Campbell's Cove

Deletion of Stage 4 Ports Authority Works

SYDNEY HARBOUR PROMENADE DESIGN RESPONSE TO SUBMISSIONS

NOVEMBER 2017

Fig. 30: Design Response

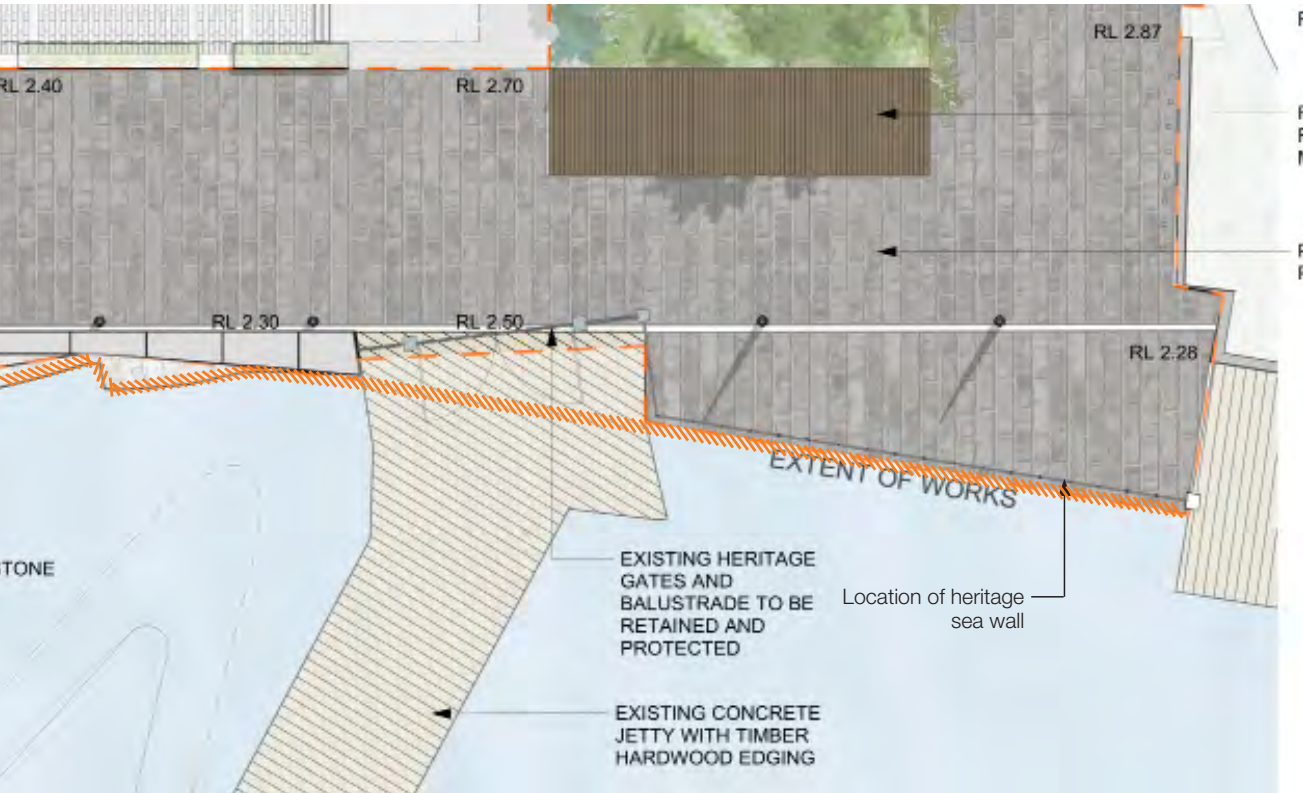
"The drawings and photomontages indicate that the boardwalk would largely obscure views of the sea wall and is likely to pose more than a minor impact."

As requested by RMS, the heritage gates and balustrade are to be retained in their original location.

With this element removed from the proposed design, an extension the promenade and introduction of timber boardwalk in this area will not be required, thus the heritage sea wall will not be impacted or hidden from view.

- Heritage gates and balustrade to remain in existing alignment
- Extend new paving to the heritage gates and balustrade at the north-east corner of the site
- No additional timber decking to be included as it would be on the wrong side of the balustrade

Fig. 35: Extent of OPT Tenancy 5 shown dashed red

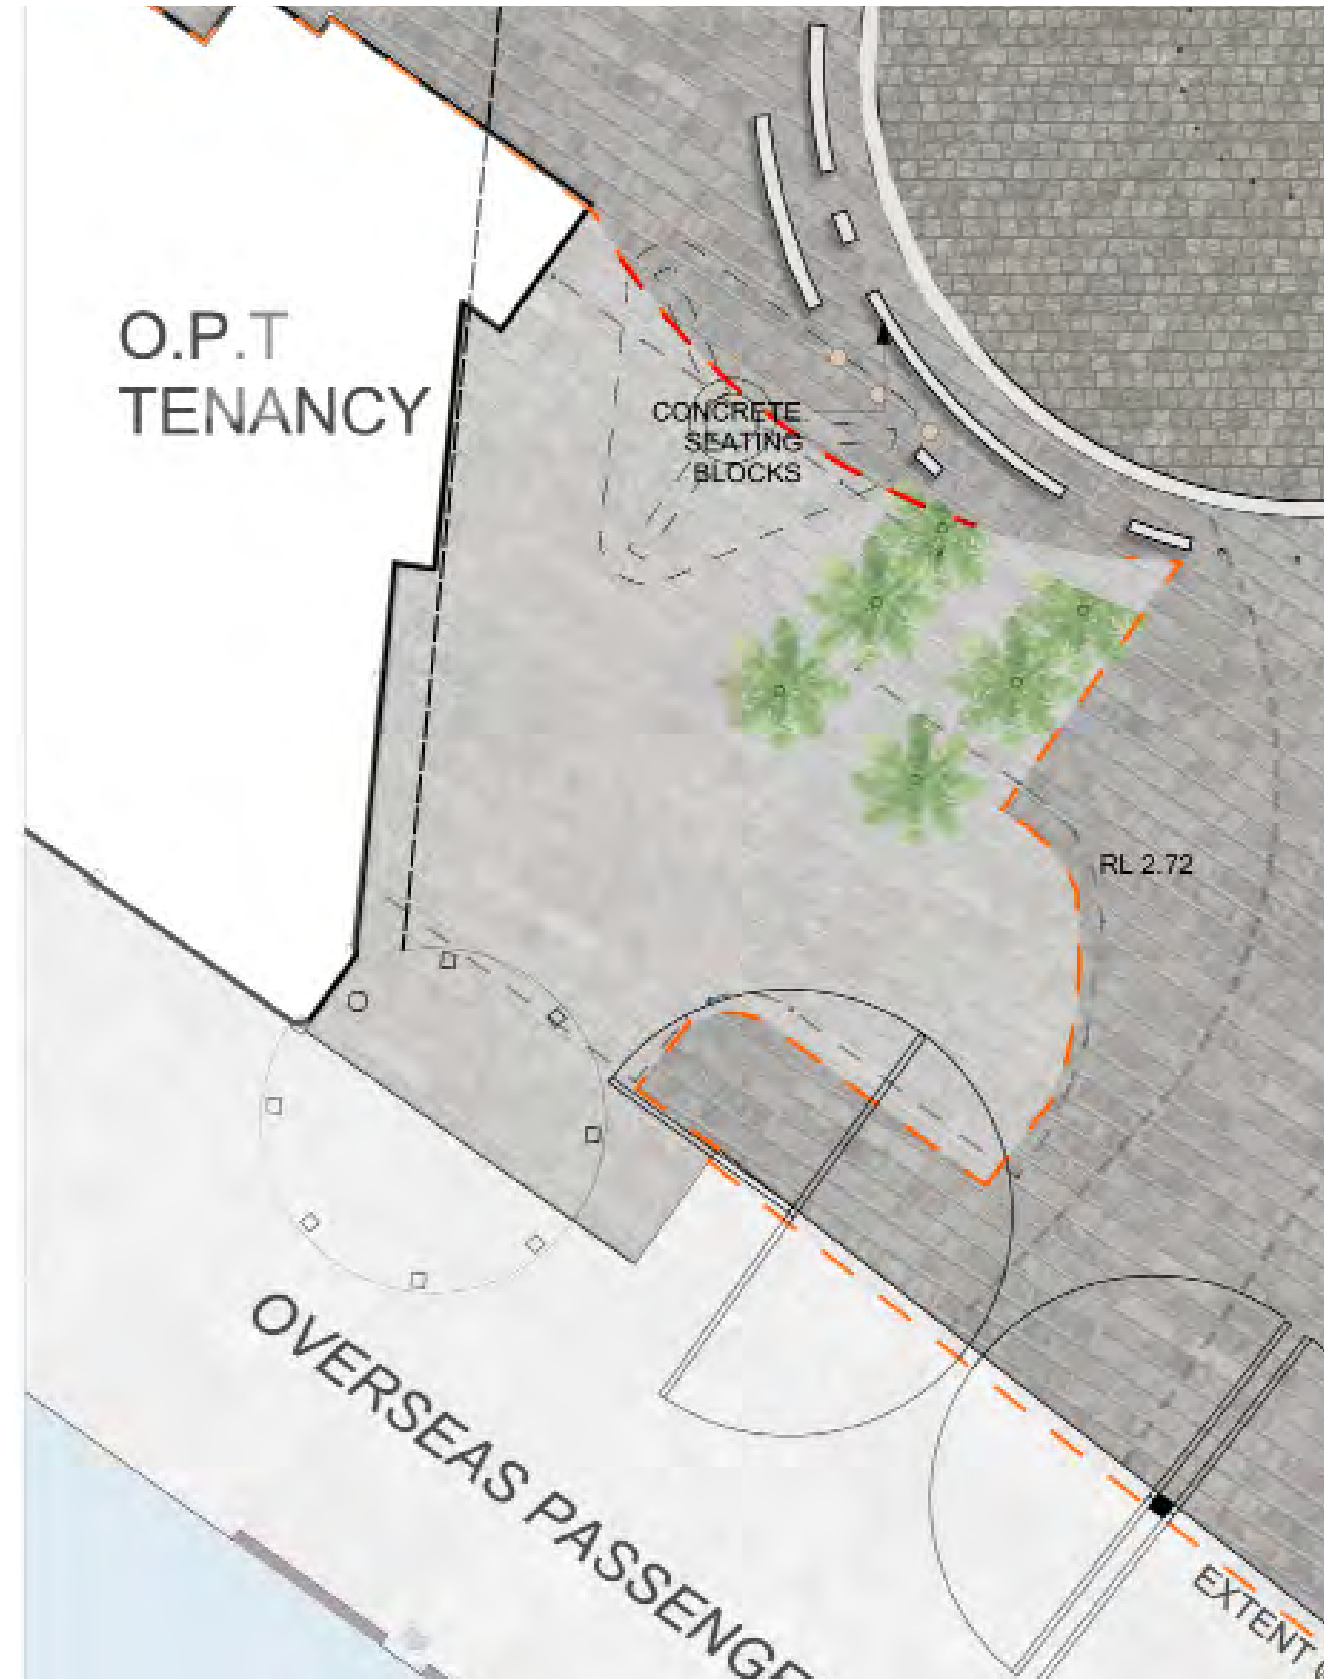
"This lease area is not a public domain area, but rather a commercially leased area for a restaurant, which will be demarcated with some sort of barrier or fence."

The design response intends to employ the use of brass inlays to delineate the extents of the Overseas passenger terminal tenancy 5. This approach has been adopted to help integrate the demarcation of the commercial area into the public domain, reduce the visual impact and eliminate any permanent walling/barriers.

- Demarcate the lease area extents with Bronze markers.
- Should the tenancy prefer further demarcation then typical outdoor dining screens can be placed.
- Any permanent fencing subject to separate application by Ports Authority.

Fig. 37: Existing turning circle to be retained

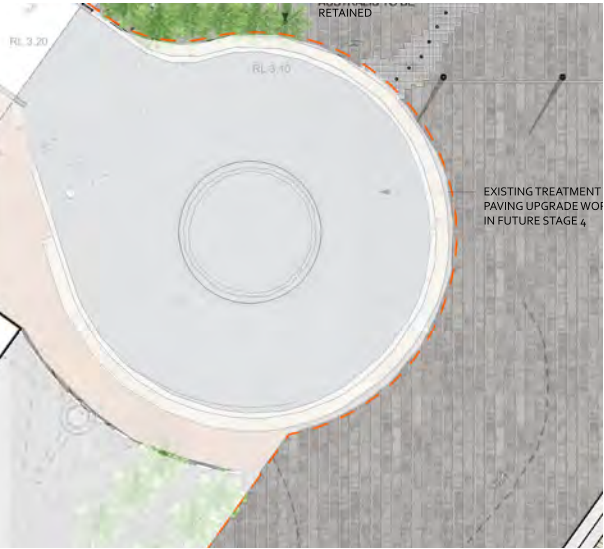
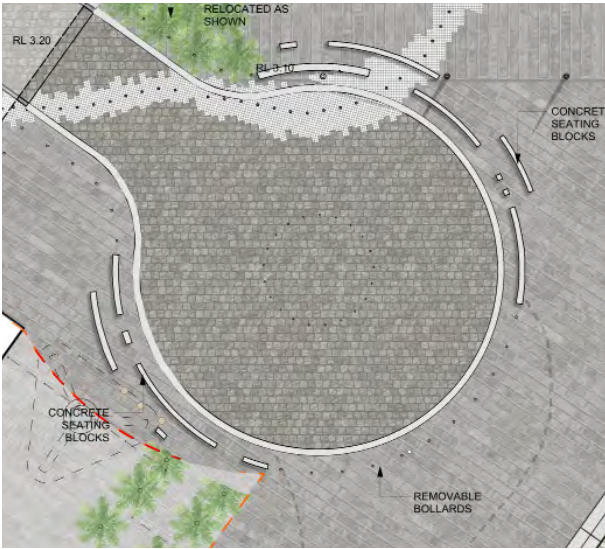
"TfNSW requests that the applicant clearly delineate the vehicle turning path by using pavers of a different colour and texture for the turning path to those around the turning path, similar to the porte cochere of the newly completed International Convention Centre Sydney,"

Revised turning circle arrangement no longer proposed as part of this project - Current turning circle to be retained, along with existing raised sandstone edge.
